# UNITED STATES PATENT AND TRADEMARK OFFICE

APPLICATION NO.	FILING DATE	FIRST NAMED INVENTOR	ATTORNEY DOCKET NO.	CONFIRMATION NO.
10/561,395	12/19/2005	Dirk Meier	MEIER9	6142

## Office Action Summary

## **DETAILED ACTION**

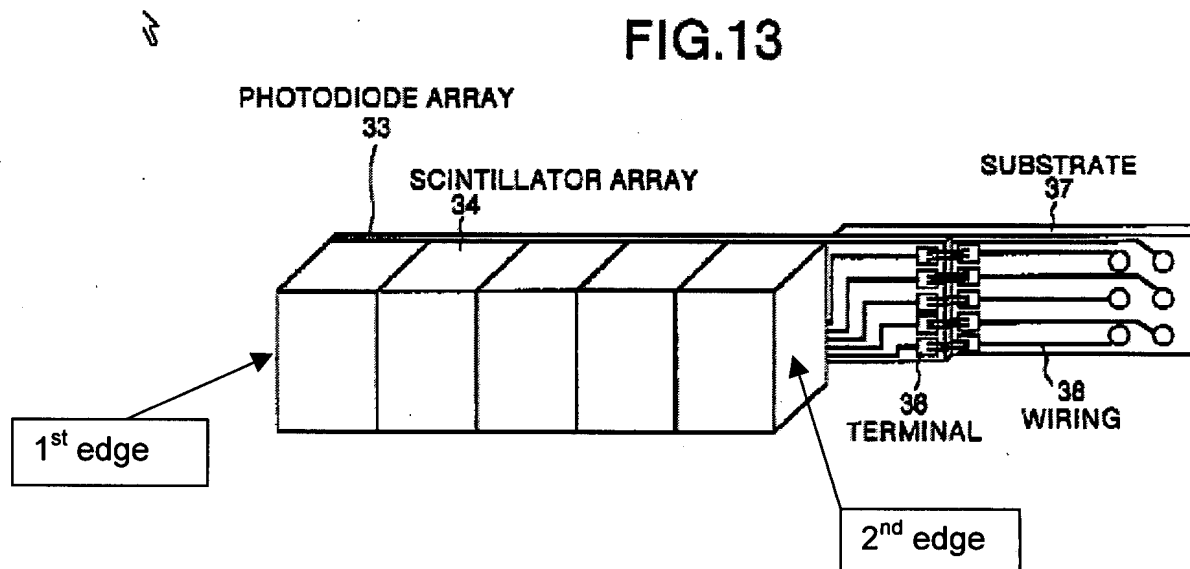
Pi teaches in col. 8, lines 59 – 60 a carrier made of ceramic material.

It would have been obvious to those ordinary skilled in the art at the time of the invention was made to modify the detector module of Nelson with a ceramic base as taught by Pi in order to have a proper heating sinking element in the detector module, to produce high quality AC coupling to the detector module or to have a rigid support or to provide physical protection for the crystals. (Col. 13, lines 11 – 19)

**FIG.15B**

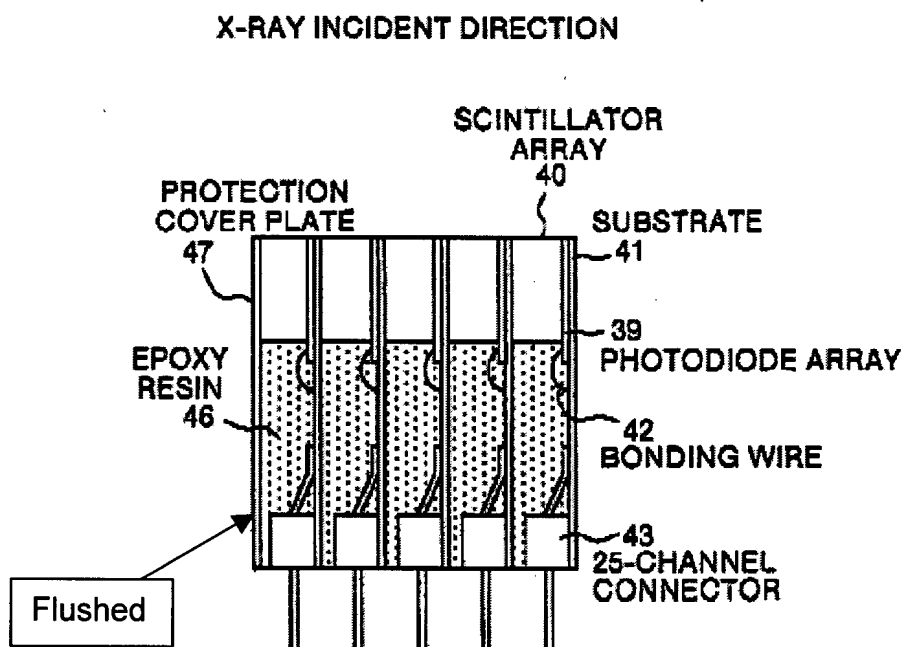
Also, In Fig. 15B (see Fig. 15 B below), Sekine shows (and therefore teaches) epoxy resin filled into the space (paragraph [0088], p. 8, lines 2- - 21) section thereof so that an upper surface thereof is flush with an upper surface of the scintillator array. It is recognized as obvious by artisans in the art that epoxy resin acts as a heat sink. Also, Fig. 15 B indicates that the electric circuit is sandwiched between the carrier and the heat sink. Fig. 15B illustrates the "flushing"

It would have been obvious to those ordinary skilled in the art at the time of the invention was made to incorporate electric circuit and epoxy resin filled into the space to flush with an upper surface of the scintillator array as taught by Sekine to the teaching

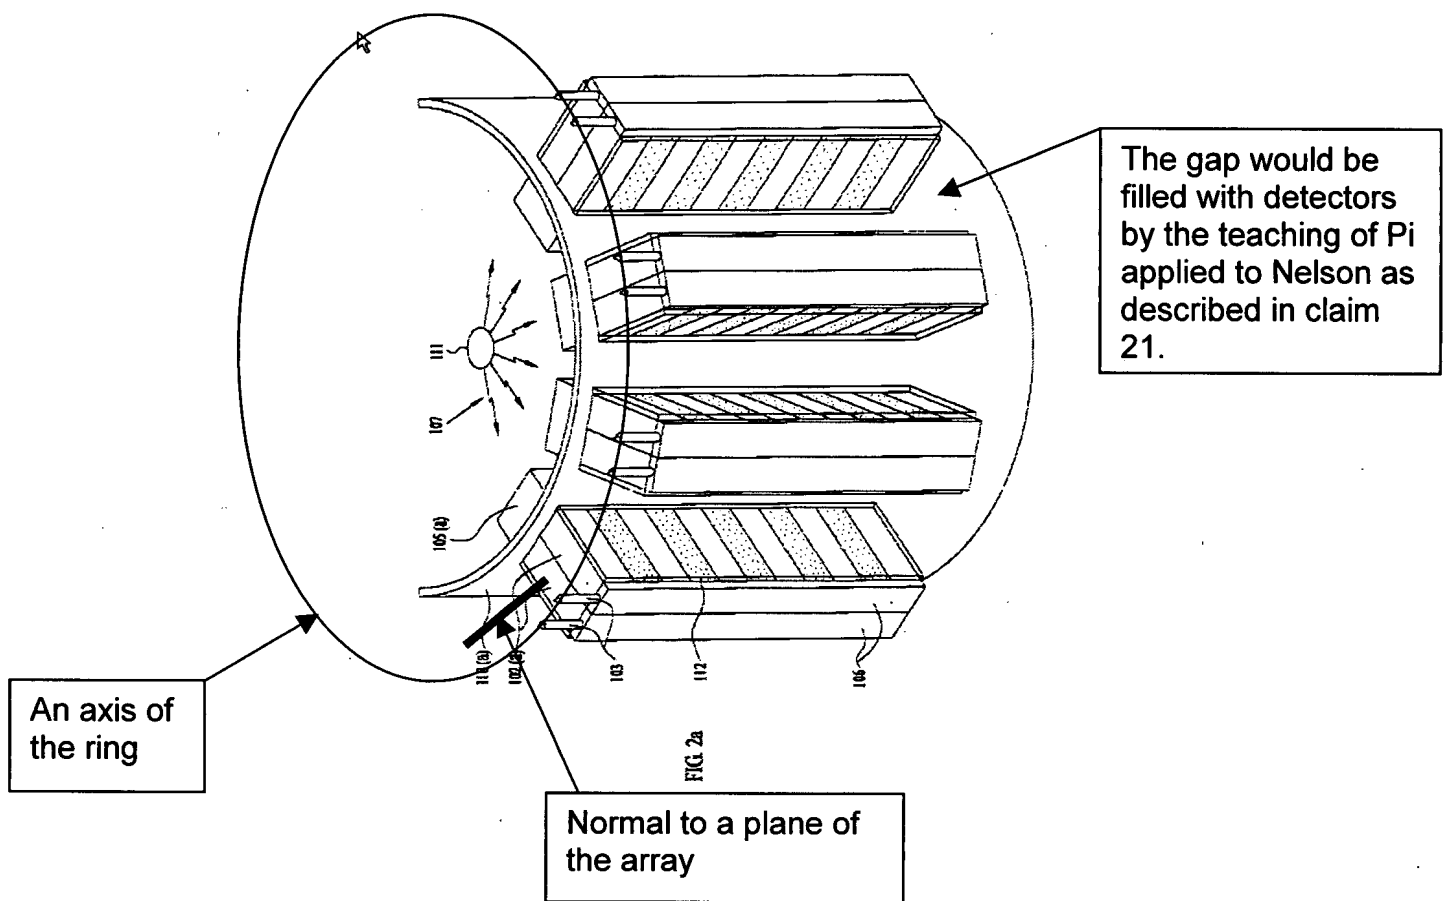
Pi teaches in col. 14, lines 30 – 33 the detector modules are arranged in an annular ring.

It would have been obvious to those ordinary skilled in the art at the time of the invention was made to modify the teaching of Nelson modified by Sekine with the

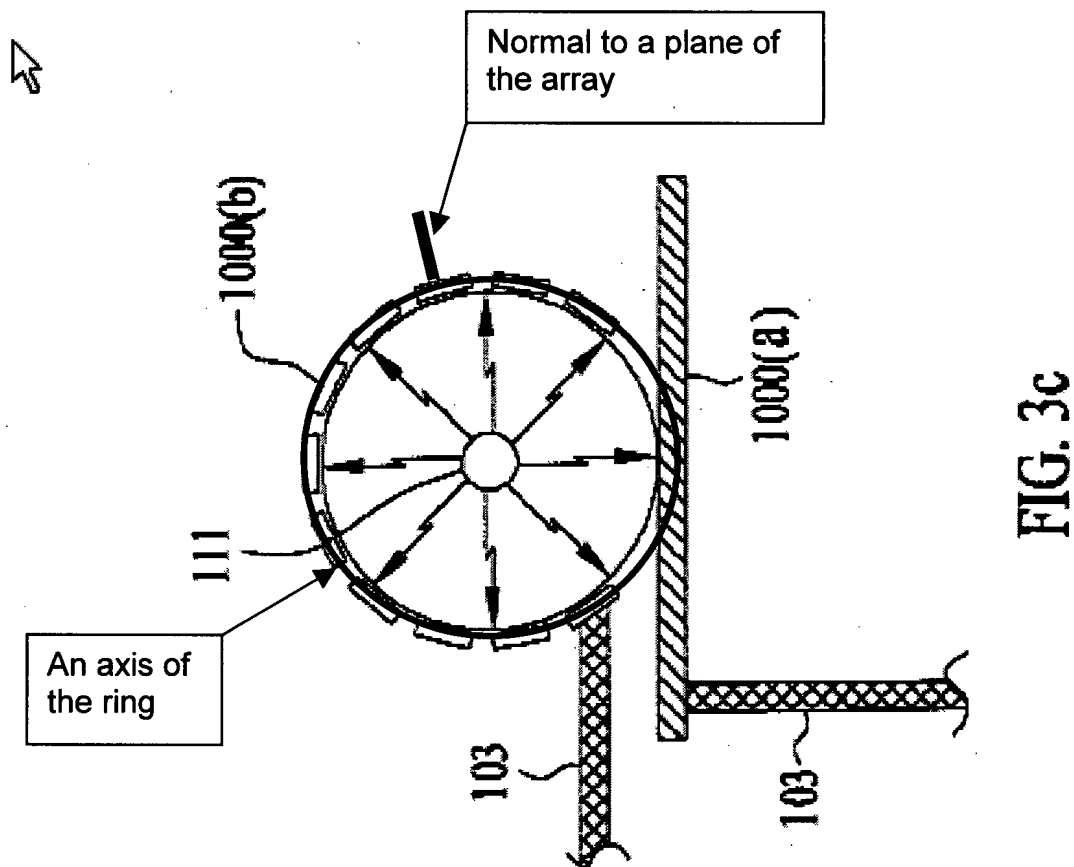
Nelson's scanner modified by Pi to a ring structure can be shown like the one in Fig. 3c (col. 9, lines 15 – 26). Then the detector assemblies of Nelson modified by Pi are orientated such that a normal through a plane of the scintillator array is orthogonal to an axis of the ring structure.
